Stages 2 & 3, Site 3 Mixed Use Development 1 – 11 Australia Ave, Sydney Olympic Park

May 2012

Section 75W Modification Major Project MP 10_0027 MOD 1

Figure 4. Approved and proposed layouts for Level 22 layout Tower 1

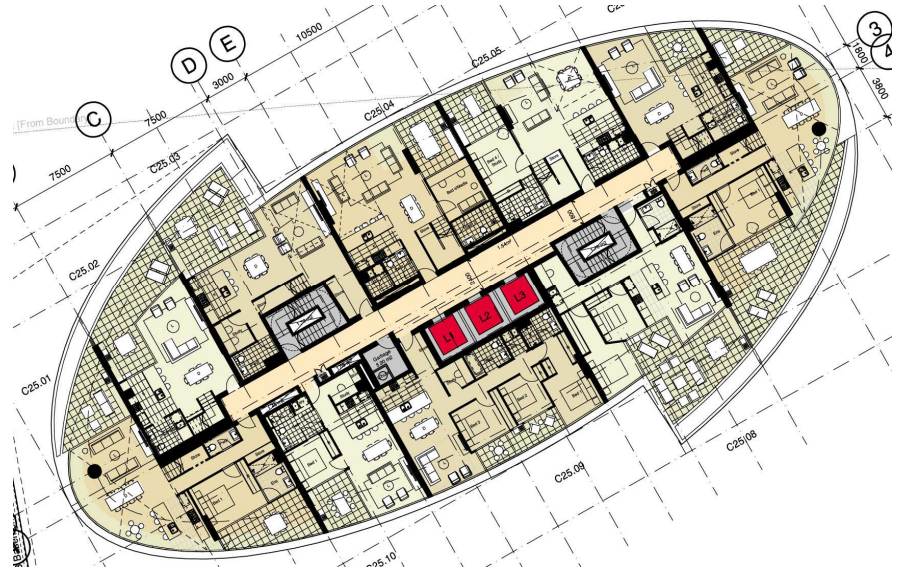
In relation to Tower 1, **Figure 1** illustrates the approved layout and proposed new layout for level 12, **Figure 2** illustrates the approved layout for levels 13 – 21 and proposed new layout for levels 13 – 18, **Figure 3** illustrates the proposed new layout for levels 19 – 21, **Figure 4** illustrates the approved layout and proposed new layout for level 22, **Figure 5** illustrates the approved layout and proposed new layout for level 23 and **Figure 6** illustrates the approved layout and proposed new layout for level 24.

Figure 6. Approved and proposed layouts for Level 24 Tower 1

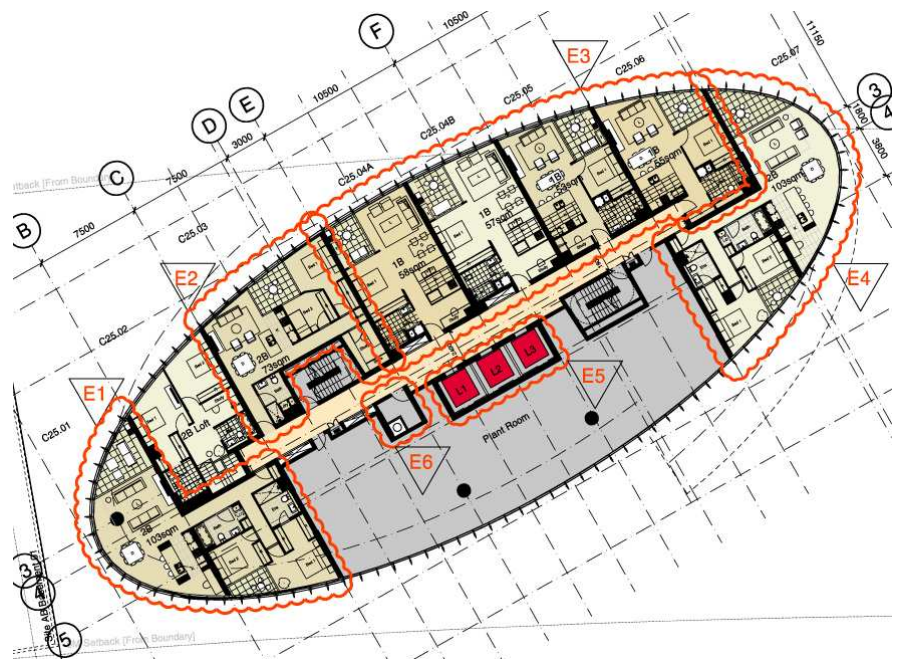
Level 24	2 x 3-bedroom loft converts to 2 x 2-bedroom single storey apartment. 1 x 2-bedroom loft and 2 x 4-bedroom lofts converts to 4 x 1-bedroom single storey apartments including 2

Level	Proposed modifications
	units adaptable. 1 x 3-bedroom loft converts to 1 x 2-bedroom single storey apartment. Lift access extended to serve Level 24 apartments. Garbage room added to serve Level 24 apartments.

Figure 8. Tower 1 North Elevation

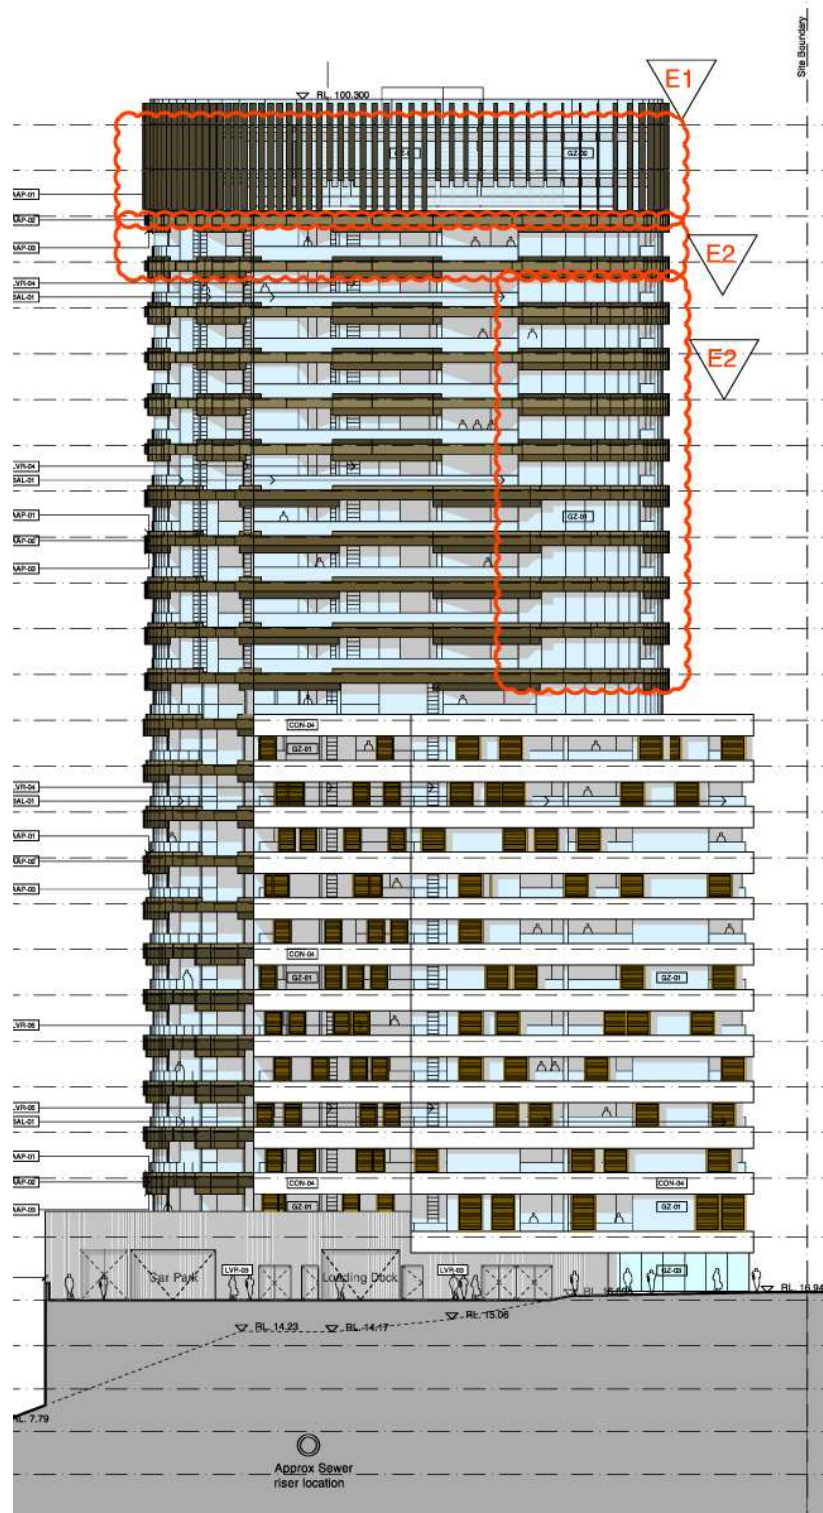
The majority of the proposed changes are internal to the approved building. Minor external changes are proposed to Levels 12 to 24 due to reconfiguration of apartments on these levels. This includes modification of approved two storey apartments on Levels 23 and 24 to single storey apartments. Refer **Figure 8** below for north elevation of Tower 1.

There are some minor external changes required to the elevations from Levels 23 and 24 resulting from the modification of the loft apartments to single storey apartments. Further minor amendments to the exterior of Levels 13 to 23 will result from the alterations to the apartment types.
